MEMORANDUM

From:	Chief Officer, Environment & Technical	To:	Chief Officer Planning & Regulatory
Our Ref:	ET/DC/MZ/P/2022/0820	Your Ref:	P/2022/0820 Res(1)
Date:	02/07/2024

AMRYWIO AMOD 07 O CANIATAD CYNLLUNIO APP/H6955/A/18/3216187 (P/2017/1032) I CANIATAU PROSESU 2,000,000 O ADAR YR WYTHNOS / VARIATION OF CONDITION 07 OF PLANNING PERMISSION APP/H6955/A/18/3216187 (P/2017/1032) TO PERMIT THE PROCESSING OF 2,000,000 BIRDS PER WEEK

MAELOR FOODS PICKHILL LANE CROSS LANES WREXHAM
Grid Ref: E 338510.4N 346705.93

The submitted Vectos report suggests that space within the car parking areas could be more formally defined and modifications to the car park have been shown in figure 3 of the submitted further response which outlines:

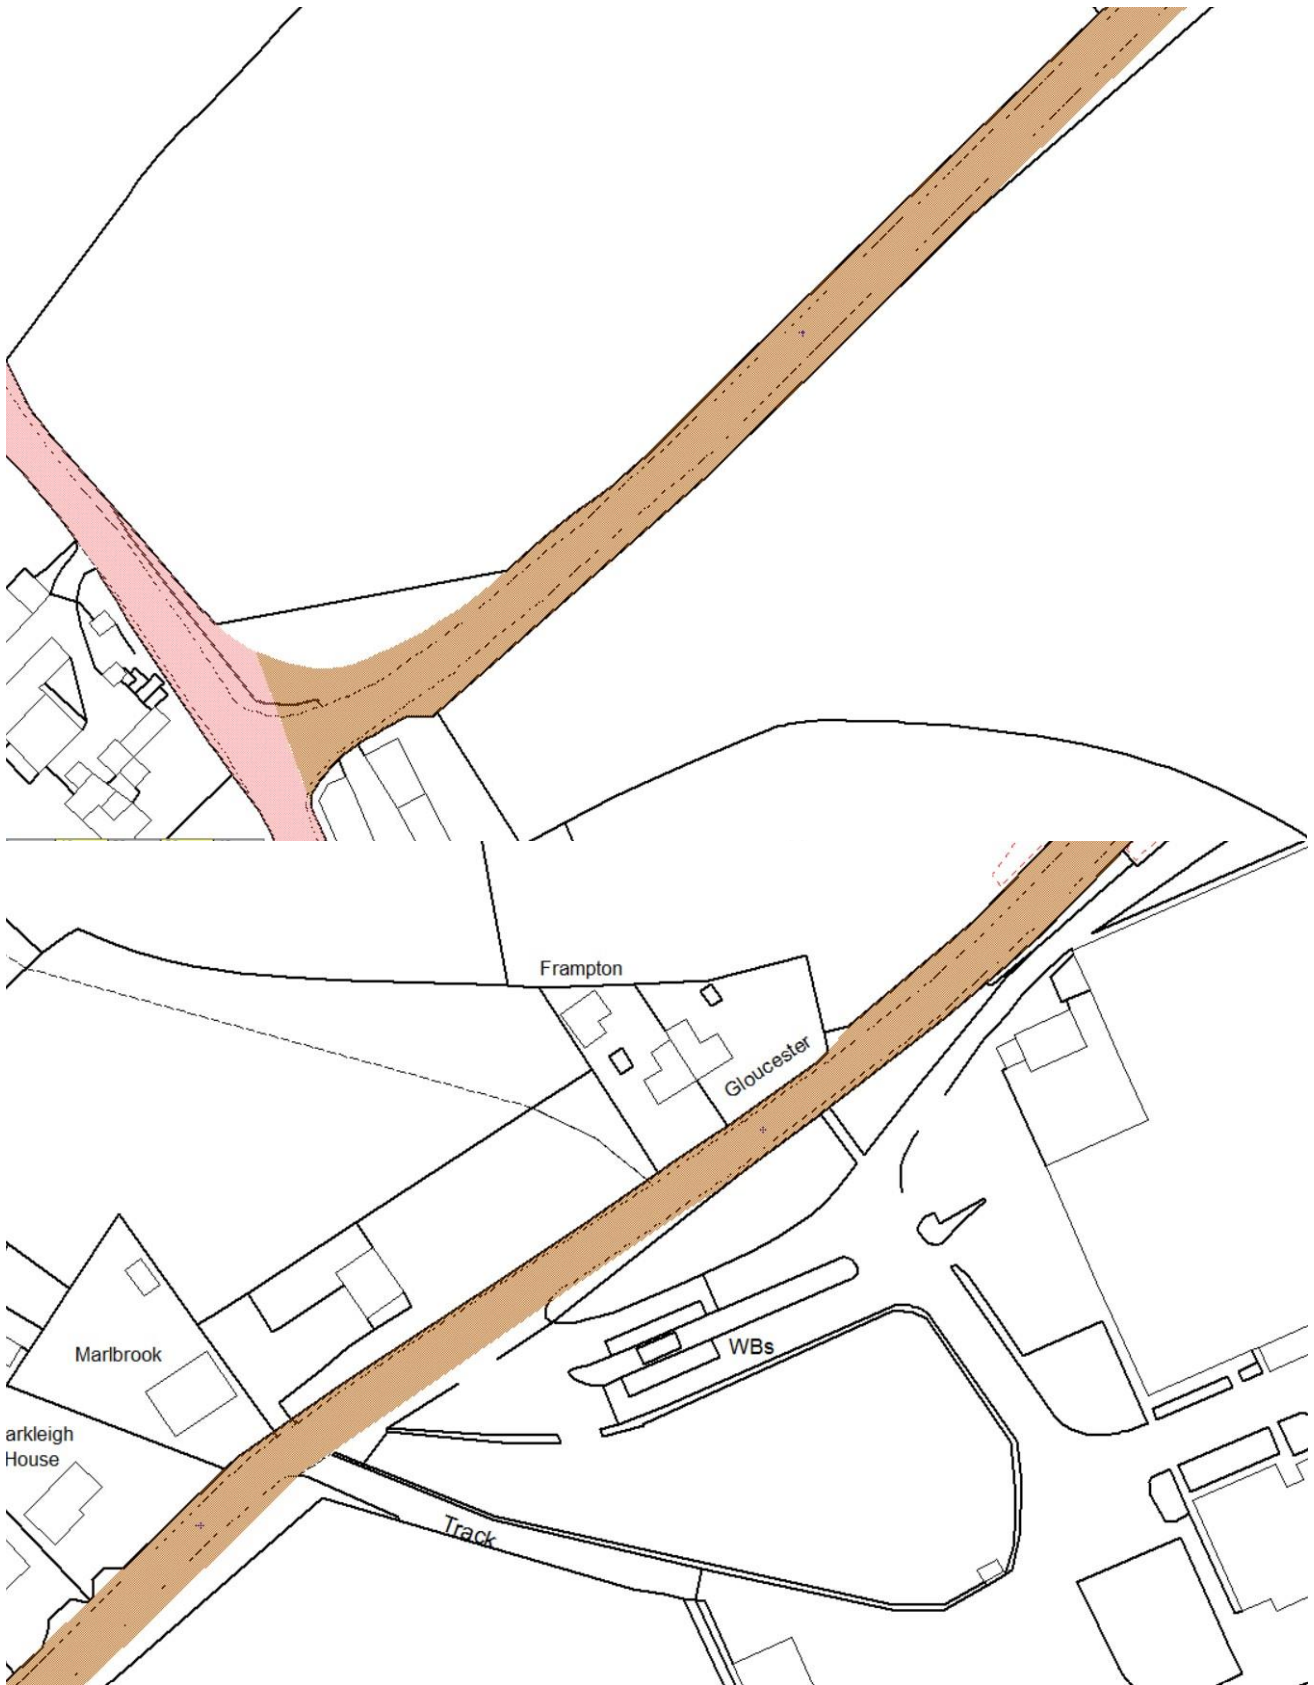
- The removal of several bays to accommodate a pedestrian footpath through the site
- The conversion of 10 existing bays into marked car sharing bays with scope to convert additional spaces subject to travel plan monitoring

- New markings to provide 15 standard mobility bays. LPG Note 16 states there is a requirement for 10% of the bays to be mobility bays, and it is considered that the enlarged 1.2m extra width could be shared between two bays to enable an increased number of spaces to be provided.

- The removal of 3 car parking spaces to provide a cycle shelter with 12 stands. The provision of 10 stands. Further detail would be required as the proposed shelter should be secure and well overlooked and the provision of cycle spaces should be provided at a rate of 1 cycle parking space per 1000 sq m of gross floorspace. The required design of cycle parking spaces is set out in LPG Note 16.

- The removal of 6 car parking spaces to provide 10 motorcycle parking spaces 1.4m wide. These should be provided with secure lockable points.
- The unmarked parking areas to be retained but potentially the installation of electric vehicle charging points. The LHA would recommend that the installation of some electric vehicle charging points and the provision of car share bays in a location of higher accessibility to the building to make them attractive to use.

- The proposals set out a total of 215 car parking spaces including 15 disabled bays, 14 cycle parking spaces and 10 motorcycle parking spaces.

The applicant is requested to submit an updated site layout plan to detail the proposed car park layout and provide details of cycle parking, motorcycle parking, car share spaces, pedestrian access path, showers and changing facilities. The LHA cannot advise on the levels required as no floorspace has been provided within the application submission.
